# **PLANNING & ZONING AGENDA ITEM #6**

***SUBJECT:*** Approval of a Preliminary Plat for Fox Creek Estates Plat 4

RE: Fox Creek Estates Plat 4 – Preliminary Plat and Construction Drawings

# FOX CREEK ESTATES PLAT 4

## PRELIMINARY PLAT

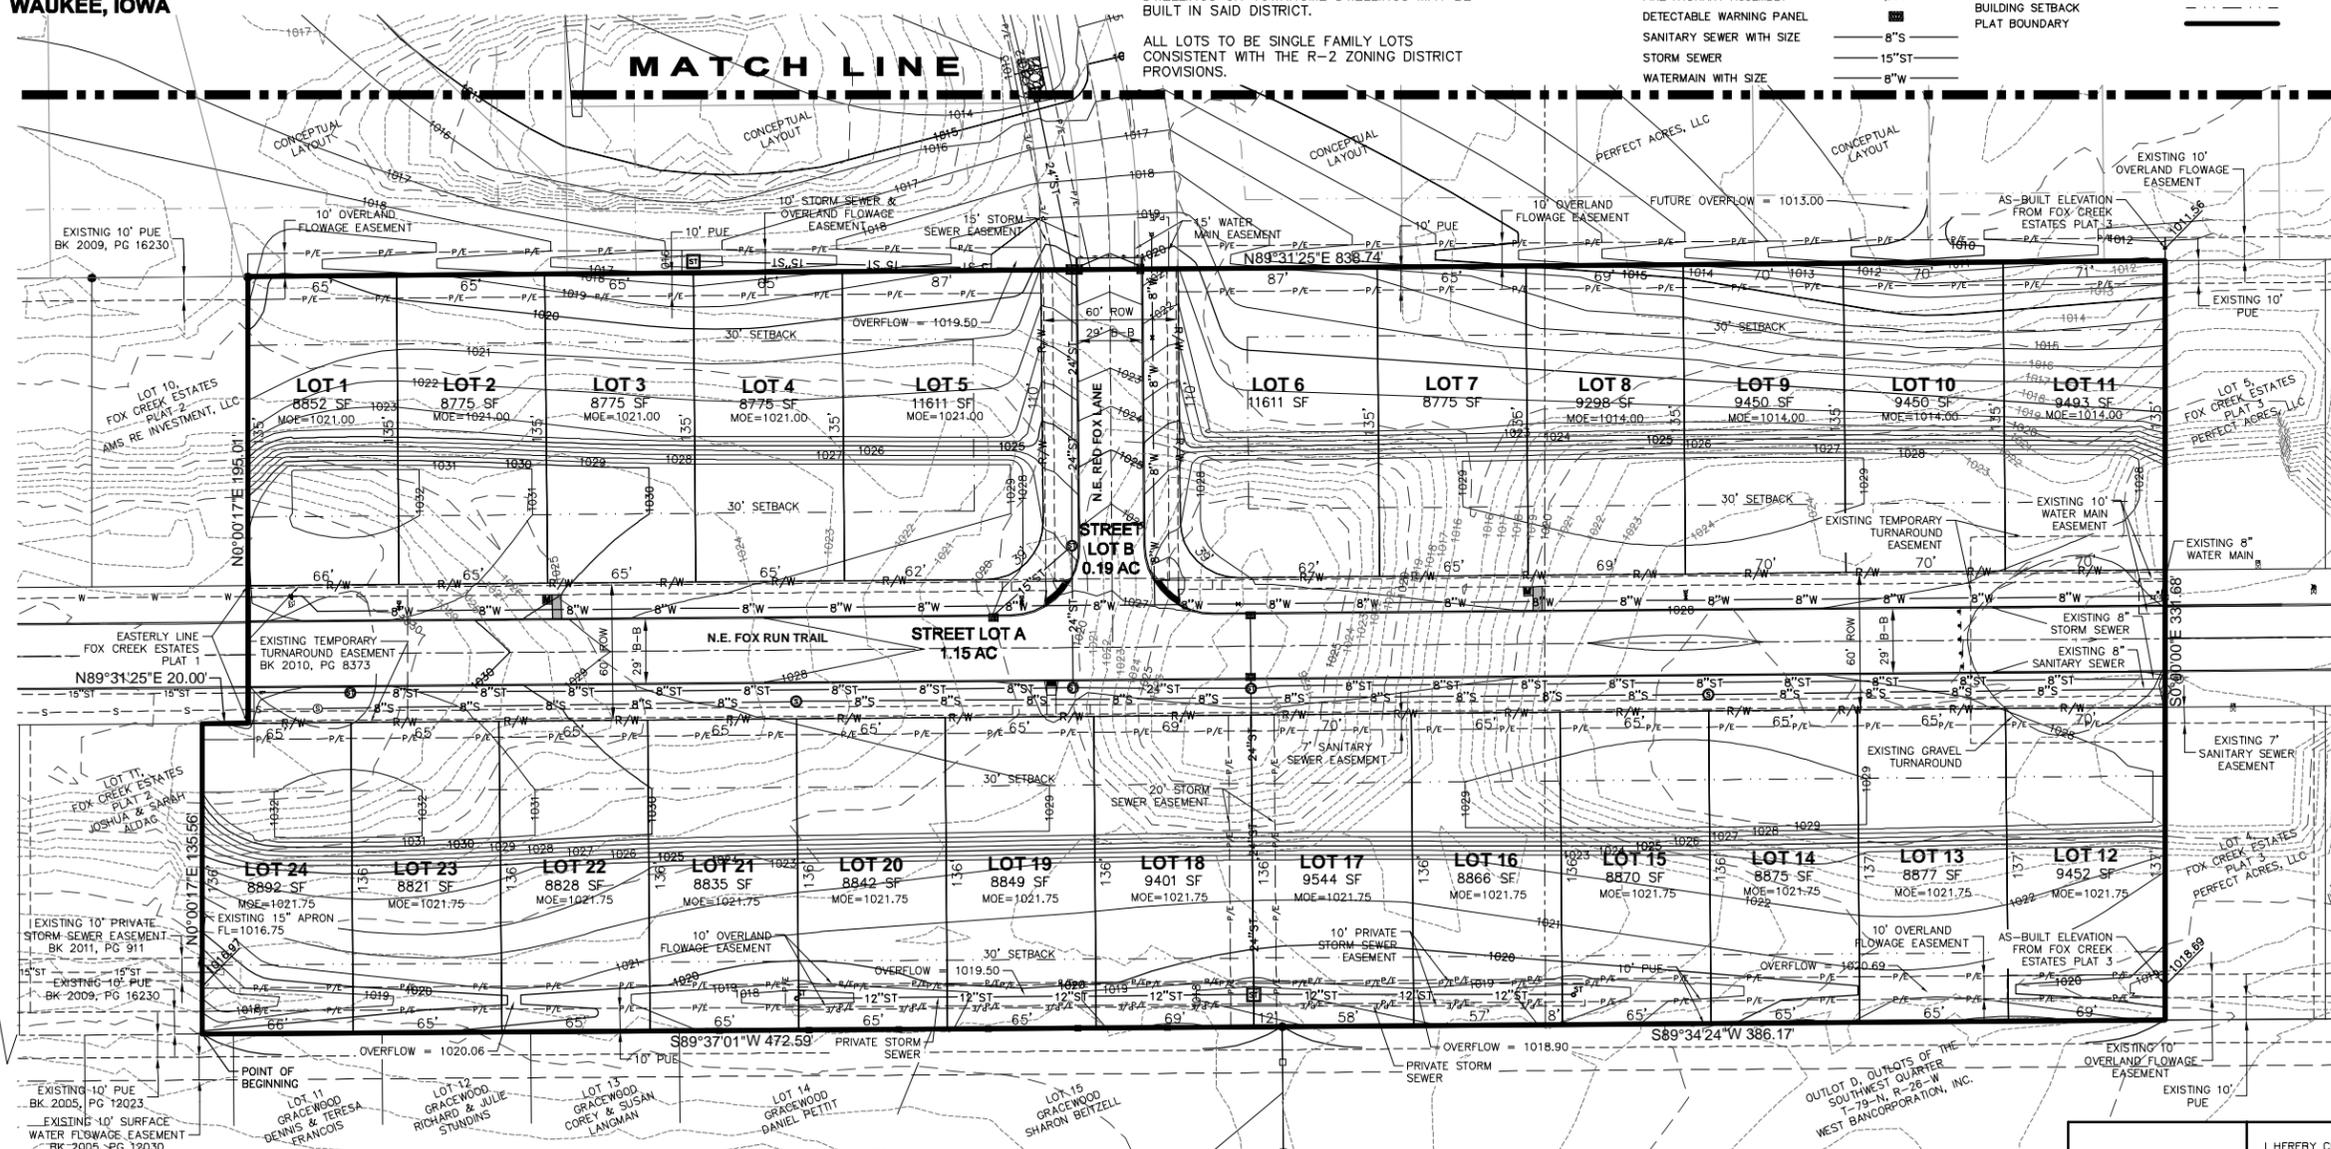
- ~~1. The Point of Beginning should be indicated on the plat. Additionally, the bearing indicated in the northwest corner of the proposed Lot 24 should be made legible.~~

- ~~2. The legal description may also need to be revised as it references Fox Creek Estates Plat 1, but there is no written indication as to where this is located in relation to the proposed plat boundary.~~

- ~~5. Staff would request that at least 100 feet of the surrounding properties be indicated as a part of the preliminary plat. Additionally, the entire area between the plat and the detention facility to the north should be included as a part of the preliminary plat. Please address.~~

- ~~7. Staff would request that the new street extending north from the plat be renamed as it is not in alignment with NE Whitetail Lane, with a suggestion of NE Red Fox Lane. Please address.~~

- ~~9. Staff would request that the grades proposed in the rear yards of Lots 12–24 be adjusted to place the low point of the swale in the center of the proposed overland flowage easement. Please address.~~

- ~~10. Verify a minimum of 2% fall across all lots within the plat.~~
- ~~11. Staff questions if the storm sewer proposed north of the plat boundary could be adjusted to stay within the anticipated future right-of-way without the need of easement across the future residential lot north of Lot 5. Please address.~~

- ~~12. The 12-inch storm sewer in the rear yards of Lots 15-21 should be labeled as private storm sewer.~~
- ~~13. Staff would request that the 12-inch storm sewer be revised to lie entirely within the overland flowage easement and tied directly into the storm manhole without the 45-degree bends. The portion of~~

- ~~14. Staff would request that the 15-inch storm sewer extending from the rear yard of Lot 4 over to NE Whitetail Lane be revised to lie entirely within the proposed overland flowage easement. The portion of easement would need to be relabeled as a public overland flowage and storm sewer easement. Please address.~~

- ~~16. The proposed 15-foot storm sewer easement between Lots 17 & 18 should be revised to a 20-foot easement.~~
- ~~17. Based upon distance from existing intakes, an additional set of intakes should be provided near the lot line of Lot 19 and 20 as the current travel distance from Plat 2 to the intakes indicated on the east side of the NE Whitetail Lane intersection is between 570-580 feet. SUDAS requires a maximum distance between intakes of 500 feet. **Based upon Waukee Standard Specifications (4.10.4) all water should be intercepted upstream at an intersection. Verify that intakes are not needed on the west side of the NE Fox Run Trail/NE Red Fox Lane intersection in addition to the proposed intakes on the east side to capture flow that may otherwise head downstream from the north side of NE Fox Run Trail to the intakes proposed at the north end of NE Red Fox Lane.**~~

- ~~20. **An overland flowage easement should be provided in the northwest corner of Lot 1 to accommodate the rear yard drainage from Lot 10 of Plat 2.**~~

**FOX CREEK ESTATES PLAT 4**  
**PRELIMINARY PLAT**

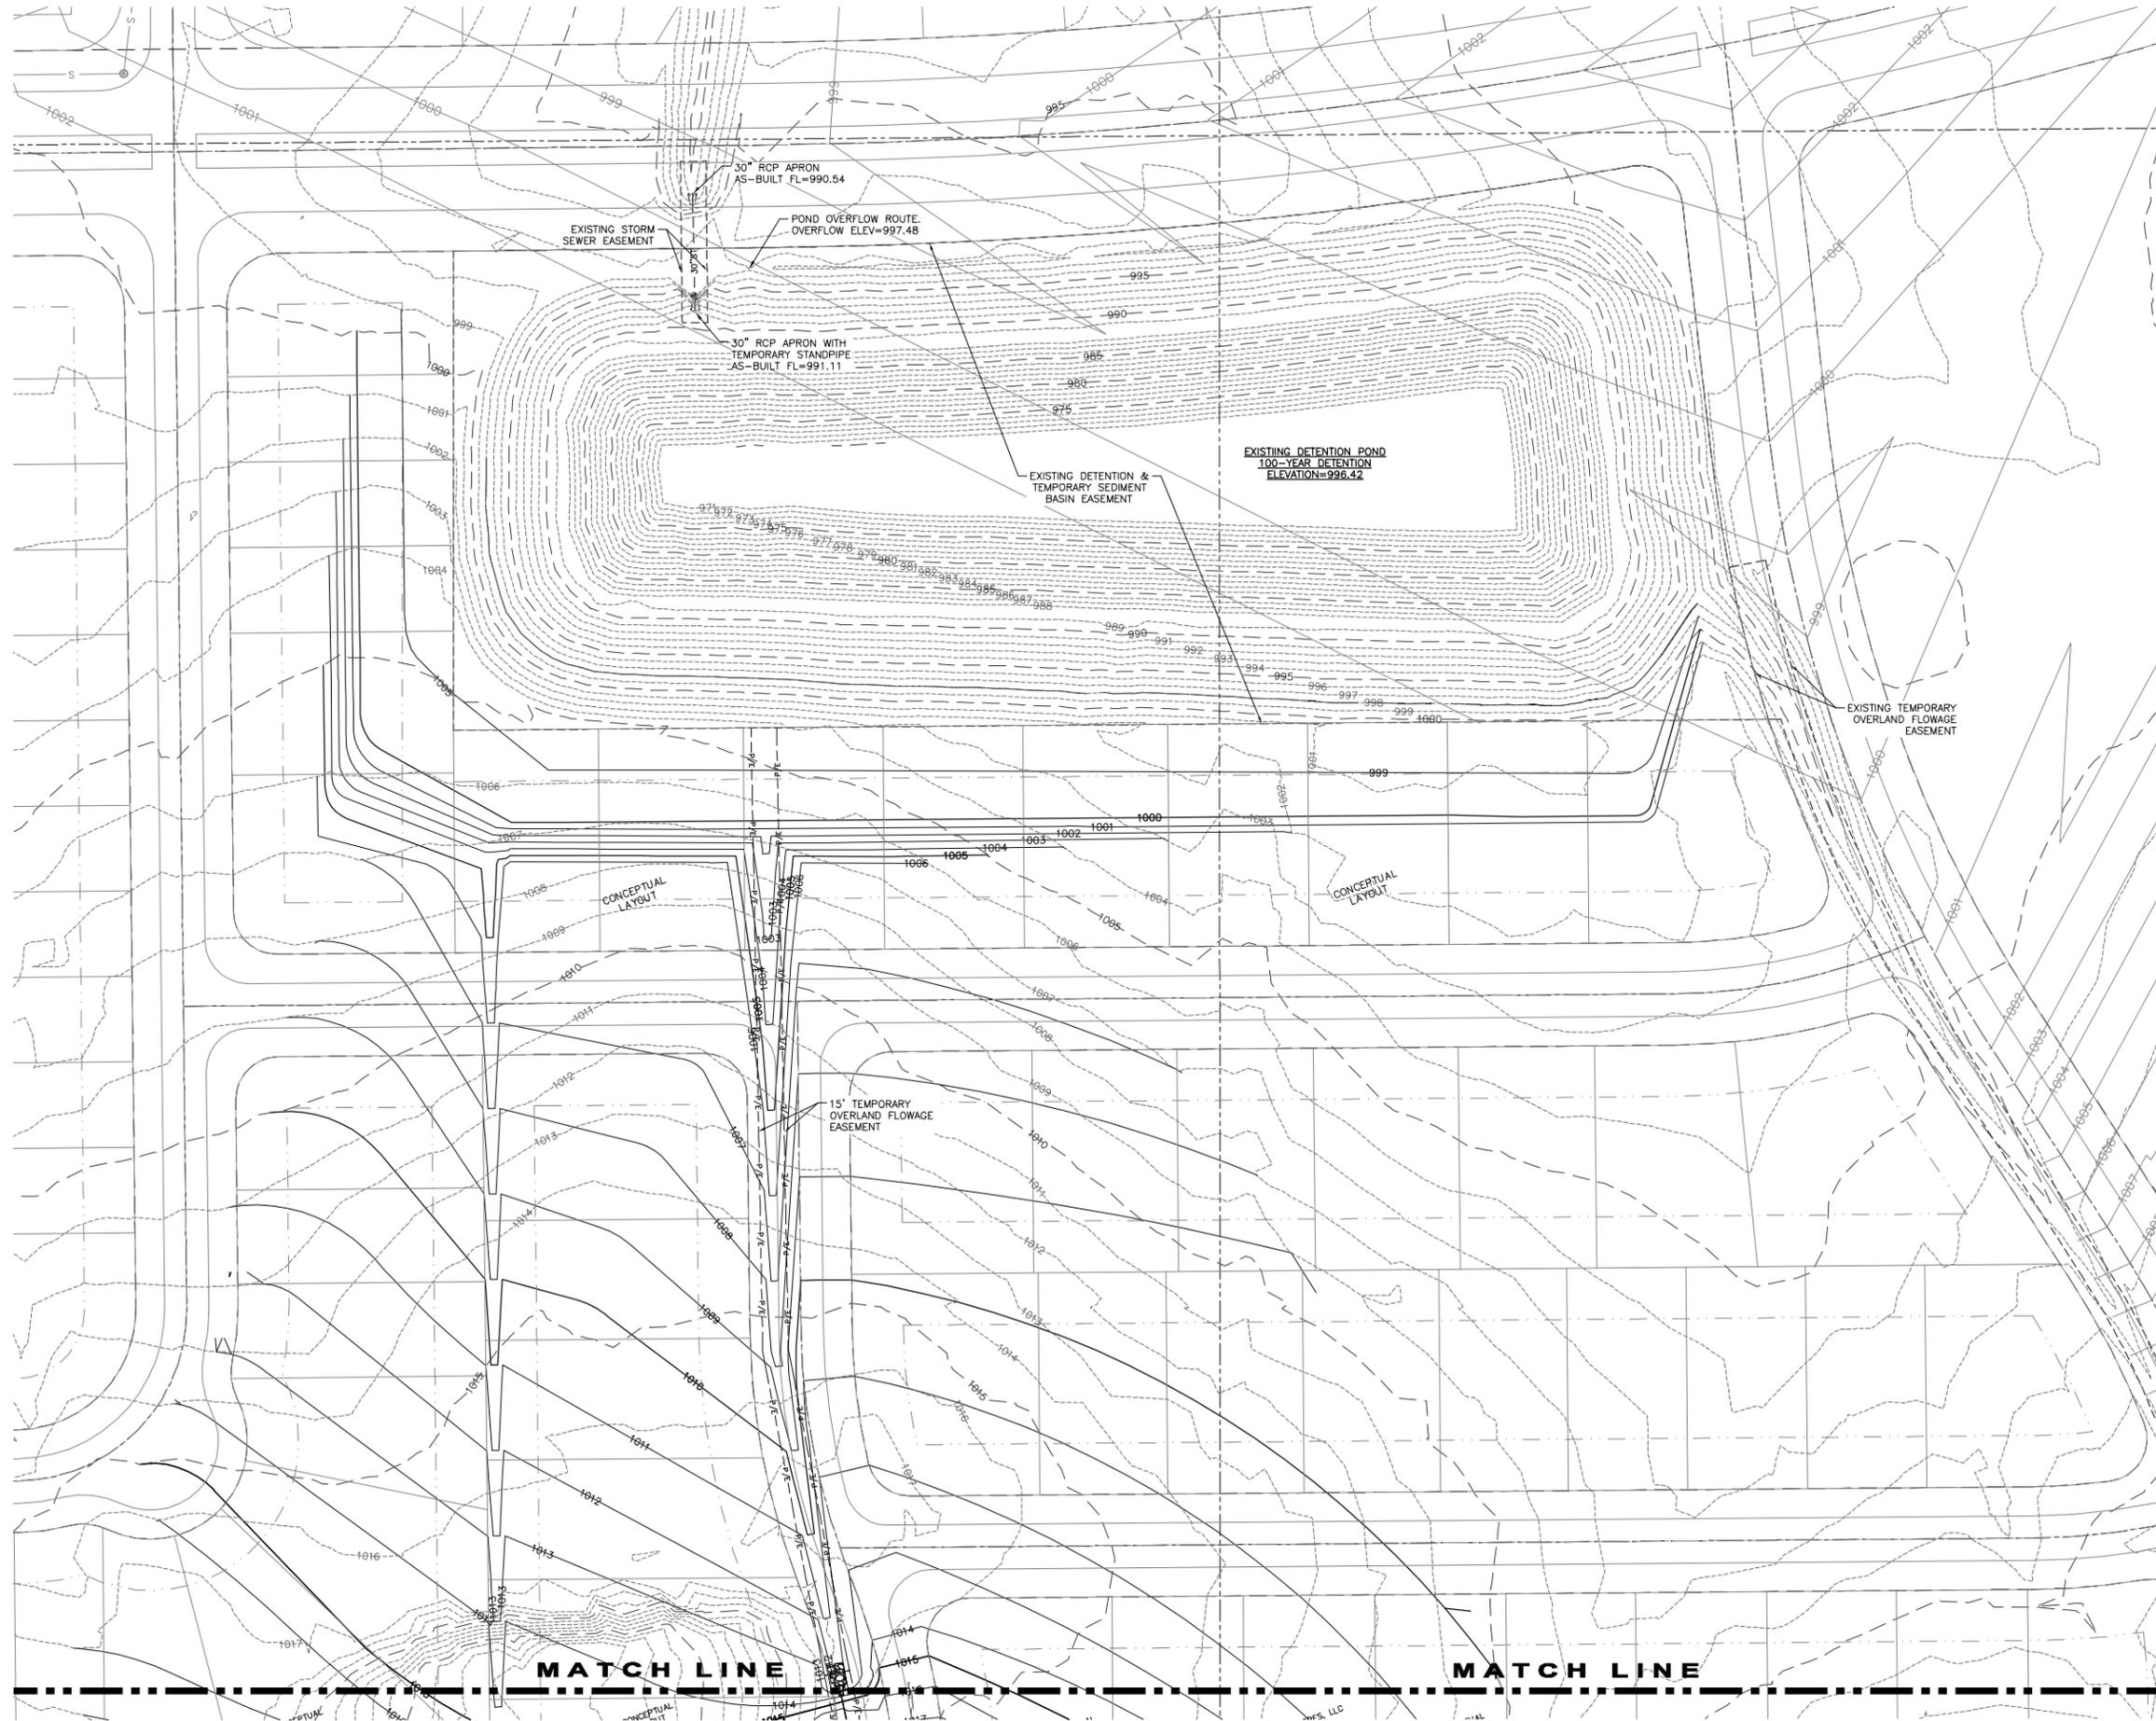
Storm water detention was accommodated for this plat and the majority of the remaining Fox Creek Estates development south of future NE Douglas Parkway with the creation of a pond near NE Douglas Parkway as indicated on the second sheet of the preliminary plat. The detention basin will be maintained by the Homeowner's Association for this plat and future Fox Creek Estates plats developed in the future.
